Charlotte-Mecklenburg Planning Department

SUBJECT: Administrative Approval for Petition No. 2007-051 VictoriaLand CO., LLC

FOR REVIEW OF REVISION #3 & 4 ONLY

ADMINISTRATIVE AMENDMENT **REVISED 3/8/2017**

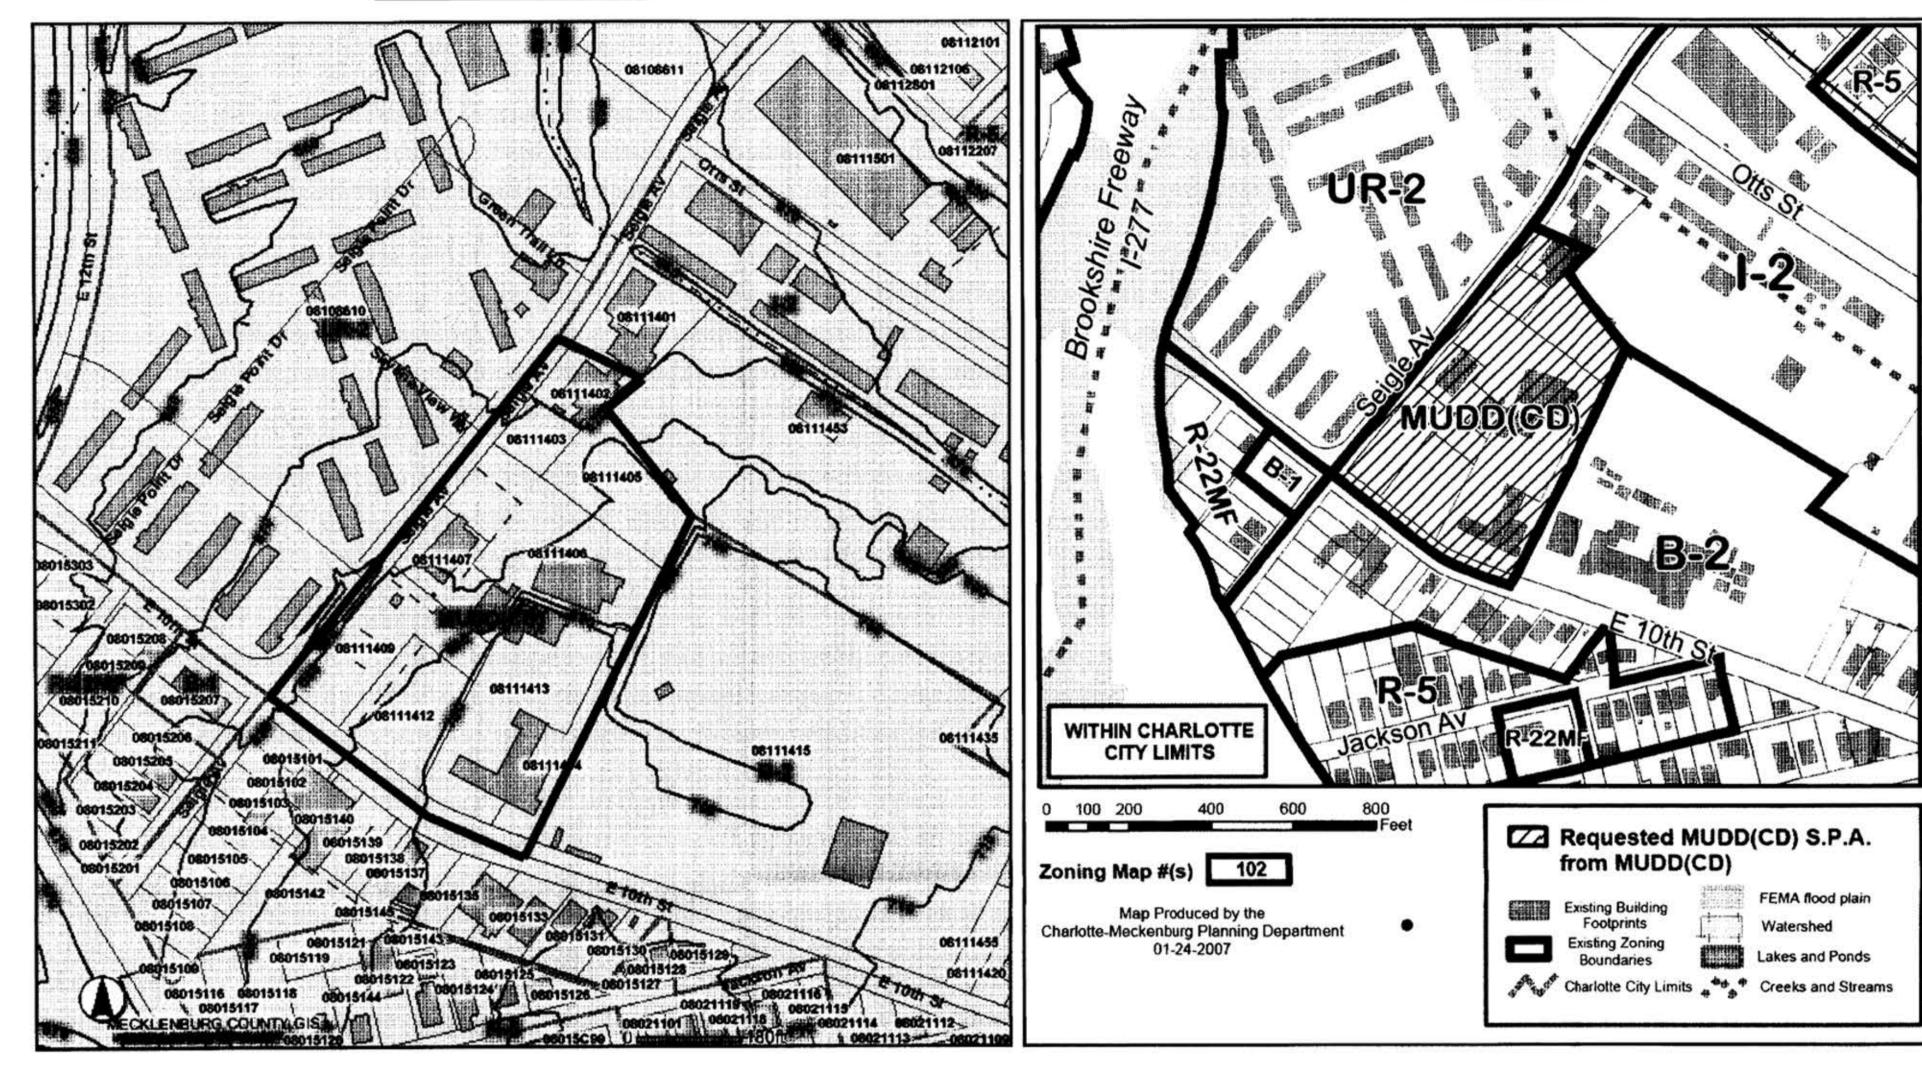
To allow changes to the storm water requirements conditional notes.

- 9. The petitioner shall tie into the existing storm water system(s). The petitioner shall have the receiving drain age system(s) analyzed to ensure that it will not be taken out of standard due to the development. If it is found that development will cause the storm water system(s) to be taken out of standard, the petitione shall provide alternative methods to prevent this from occurring. Existing impervious area will be credited

- - A. The Petitioner shall comply with the Charlotte City Council approved and adopted Post Construction Stormwater Ordinance. The Site shall not be eligible for any exemptions referenced in Section 18-105(a)(7) of the Post-Construction Stormwater Ordinance.
